SUBMISSION OF REPRESENTATIONS AND FORMAL OBJECTION TO PLANNING APPLICATION REF: 2021/3009/P AT WORKSHOP REAR OF 38-52 FORTRESS ROAD, FORTRESS GROVE, LONDON NW5 2PA

'Variation of condition 3 (approved plans) of planning permission dated 28/01/2019 Ref 2017/6788/P for Works to depot building (Studio B) comprising increasing height of existing parapet, erection of a single storey roof extension, rear infill extension, external alterations and landscaping of courtyard; provision of UKPN substation and external alterations to Railey Mews.'

Figure 1.2: Approved East Elevation (ref: 2017/6788/P)

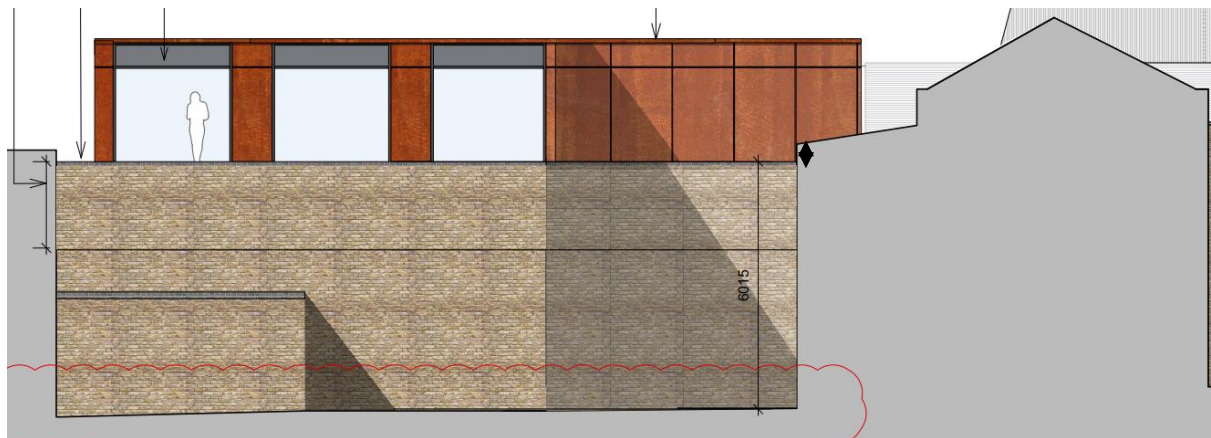
Having reviewed the plans for the approved and current application, it is evident that the current proposal seeks to increase the height of the eastern wall, which marks the termination between the main building and the set-back roof addition of the office building. This wall also sits immediately adjacent to the rear (south-west) elevation of our client's property at No.1 Railey Mews.

Although we were unable to find a document that confirms the exact height increase at this location, we undertook a site visit on Wednesday 21st July and can estimate that the eastern wall will rise approximately 1 metre(+) above the approved eastern wall. No doubt a full measured survey at the site would assist in the accuracy of these figures.

For context, figures 1.2 and 1.3 below show the approved east elevation and the current proposed east elevation.

Although the increase between figures 1.2 and 1.3 only appears marginal, the eastern perimeter wall now rises above the height of the adjacent windows at the rear first-floor level of No.1 Railey Mews, which serves our client's kitchen, dining and living areas. The elevated position of the eastern wall in relation to the southern elevation of our client's property are clearly shown in the photographs within Appendix 1 and at figure 1.4.

Figure 1.5: Approved Roof Plan

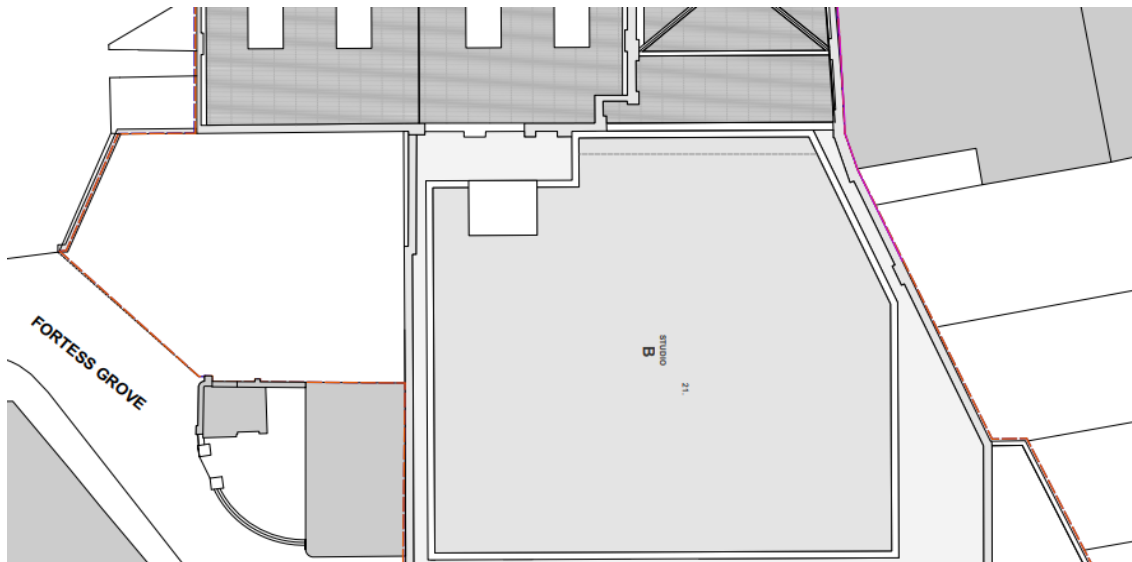
We have undertaken a review of the updated GIA Daylight and Sunlight Addendum (dated 18th June 2021), which forms part of the submission documents for the current application. In parallel, we have reviewed the Daylight and Sunlight Assessment for the approved development. We have identified inconsistencies with the set-back of the roof addition at the east elevation between the approved roof plan and proposed 3D Massing Model, as shown below in figures 1.5 and 1.6 respectively.

The proposed 3D Massing Model clearly shows that the roof addition is notably set-back from the eastern elevation in the current planning application. In comparison, the roof plan submitted with the approved development extends much further towards the east elevation, and crucially our client's property at No.1 Railey Mews.

In light of this, our client is concerned that the results of the proposed Daylight and Sunlight Analysis are deficient and are not a true reflection of the actual impact caused by the development. If the massing is actually greater at this part of the scheme (as shown in the original approval roof plan), this may detrimentally impact upon the daylight, sunlight and the general amenity enjoyed by our client.

On this basis, we consider that the Applicant should confirm whether the proposed 3D Massing Model is correct or not. If it is incorrect, we request that the Applicant re-submits the Daylight and Sunlight Assessment to confirm whether there is any detrimental impact to adjacent occupiers. We consider that the application should be classed as 'invalid' until this assessment has been provided.
